BAR Meeting
December 10, 2008

ISSUE: Addition and Alterations

LOCATION: 310 North Fayette Street

BAR CASE #2008-0222, 0223 12/10/2008

Figure 4: Proposed south elevation

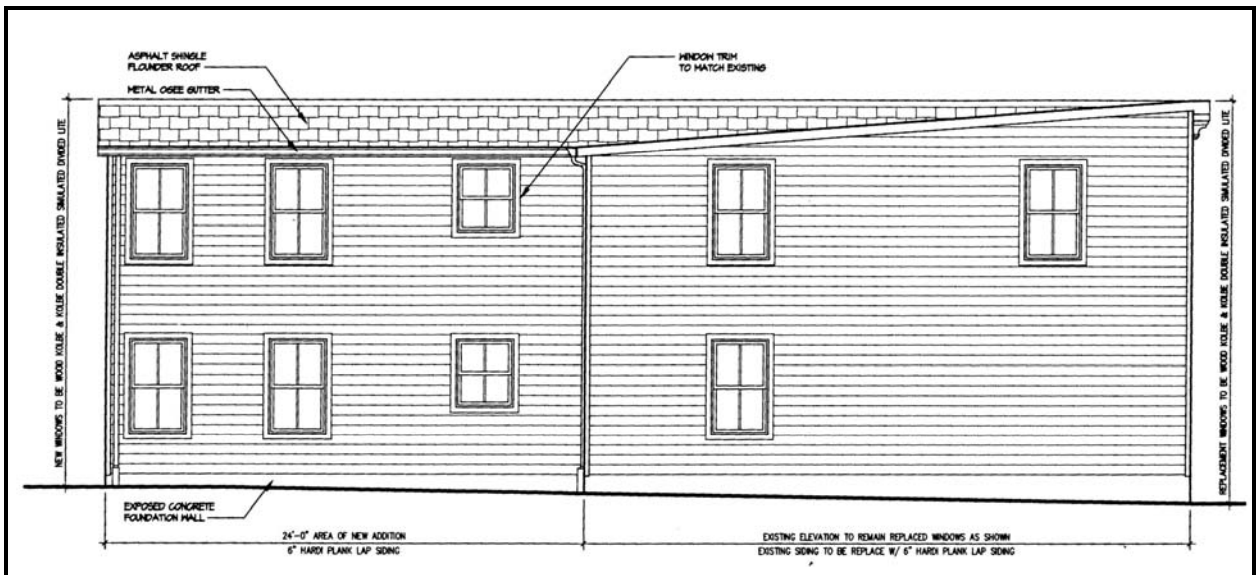
Generally, Staff supports the proposed addition and alterations. The house at 310 North Fayette Street has been in disrepair for some time and the rehabilitation of this turn of the century house will enhance the Parker-Gray neighborhood. The addition will be visible from the rear alley, as well as a narrow break between houses on Queen Street. Staff supports the installation of the historic five panel door purchased by the applicant, but would recommend that the two small two-over-two windows on the south side of the addition be changed to one-over-one wood windows. In the opinion of Staff, the proportions of these windows warrant a simpler, one-over-one light configuration.

4. That the small two-over-two wood windows on the south elevation be replaced with one-over-one wood windows;
5. That the historic five panel front door shown in the photograph be installed rather than the four panel door shown on the plans;

Figure 10: Proposed front door

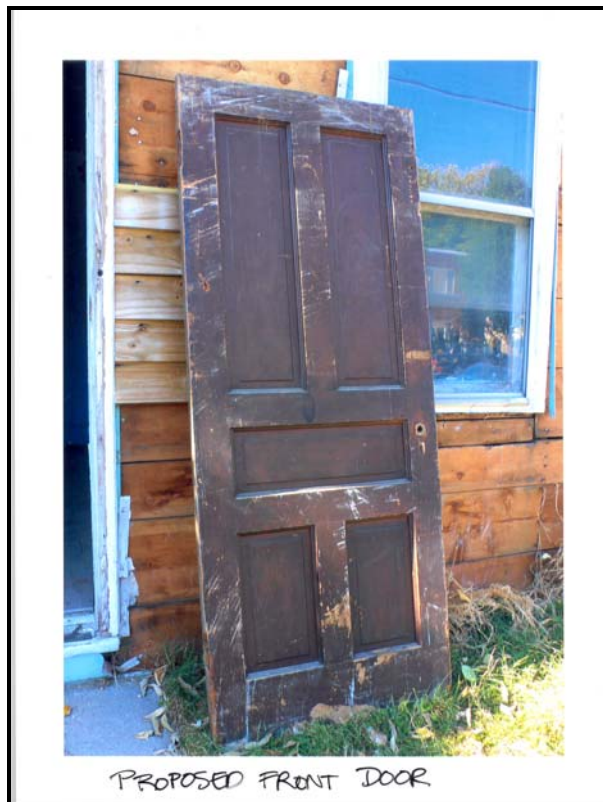
The applicant also proposes alterations to the historic portion of the house, including the replacement of the windows and front door and the installation of new siding. The windows will match the Kolbe & Kolbe windows on the addition. The new door will be an historic five panel wood door (see attached photograph), not the four panel wood door shown on the plans. The siding on the front will be beveled wood siding. The front siding will match the profile of the Hardi-plank siding proposed on both the addition and the sides of the historic house.
